1 APPLICATION SUMMARY

Application information	
Address	2 & 10 Coastlink Court, STAPYLTON QLD 4207
Lot and plan	Lot 203 SP329487, Lot 202 SP329487
Site area	Lot 202 SP329487 – 41,650m ² Lot 203 SP329487 – 44,170m ²
Type of development and proposed use	MCU for Industry (modular building assembly with ancillary office) ROL for a Boundary Realignment Operational Work – Change to Ground Level
Categories of development and assessment	Material change of use (code assessment) Reconfiguring a lot (code assessment) Operational work (code assessment)
Properly made date	3 February 2026
Decision due date	21 April 2026
Applicant and Applicant's consultancy team	FPI Queensland Pty Ltd – Applicant Gassman Development Perspectives – Town Planning, Engineering, Landscape consultants Fraser's Property Industrial Queensland Pty Ltd – MCU proposal plans Rytenskiid Traffic Engineering – Traffic consultants Acoustic Works – Acoustic consultants Riskcon Engineering – Dangerous Goods Storage assessment

The purpose of this report is to assess an application for a development permit for a material change of use to establish Industry (modular building assembly and ancillary office), reconfiguring a lot for

Figure 3: Site Plan (Source: FPI Queensland Pty Ltd)

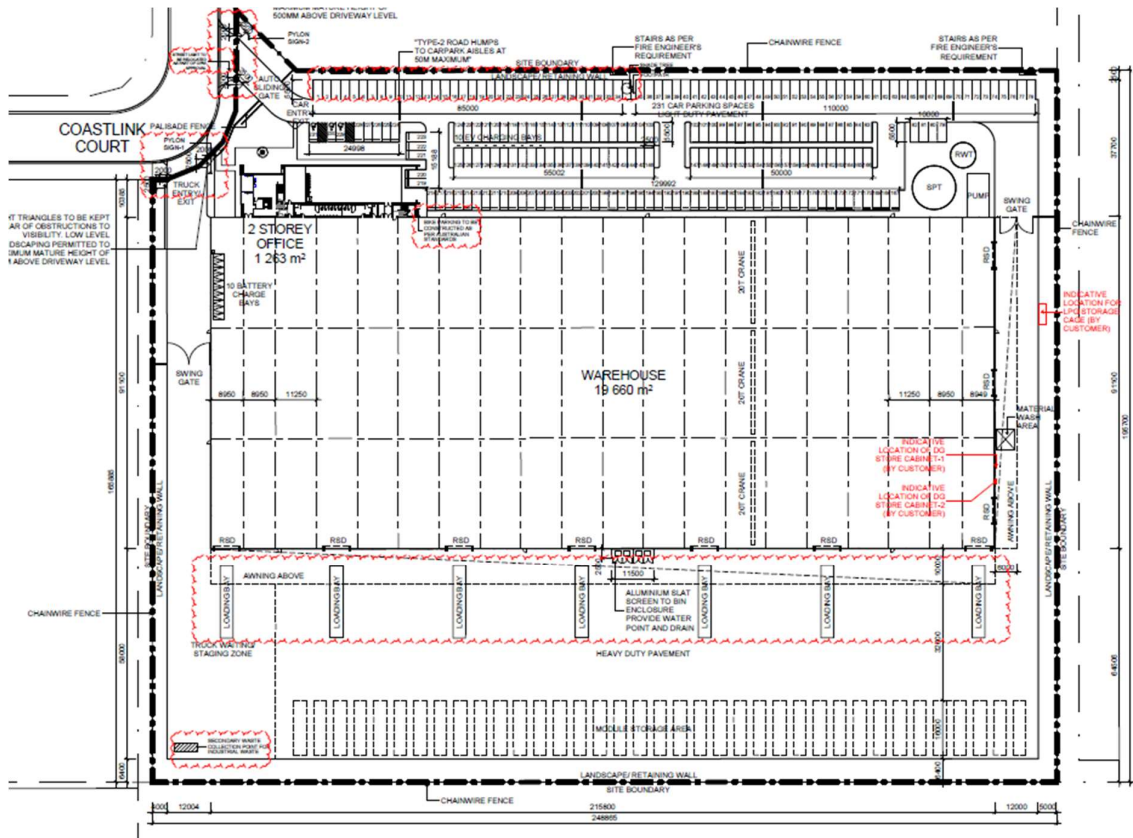
The submitted drawings show gates at both vehicle access points. Compliance with Acceptable Solution AS9.1 of the Car Parking, Access and Transport Integration Constraint Code is not achieved.

Both gates are set back within the site, 16m for the light vehicle access and 50m for the heavy vehicle access.

Compliance with Acceptable Solution AS11.2 of the Car Parking, Access and Transport Integration Constraint Code requires access to streets adjacent the site to comply with the requirements of AS2890.1 and AS2890.2. The submitted drawings show the vehicle crossings located on the inside bend on Coastlink Court. Sections of on-street car parking are located on northern side of the light vehicle access. Vehicles parked in these areas will obstruct the sight lines of drivers, particularly those in cars exiting the site.

Section 3.2.4(a) of AS2890.1:2004 and Section 3.4.5(a) of AS2890.2:2018 requires provision of 69m entering sight distance. To achieve this, officers have recommended a condition requiring installation of a 'No Stopping' yellow line.

Transport Assessment intend to impose a condition of approval requiring that the security gates remain open during the hours of operation, ensuring unrestricted access for employees and visitors.
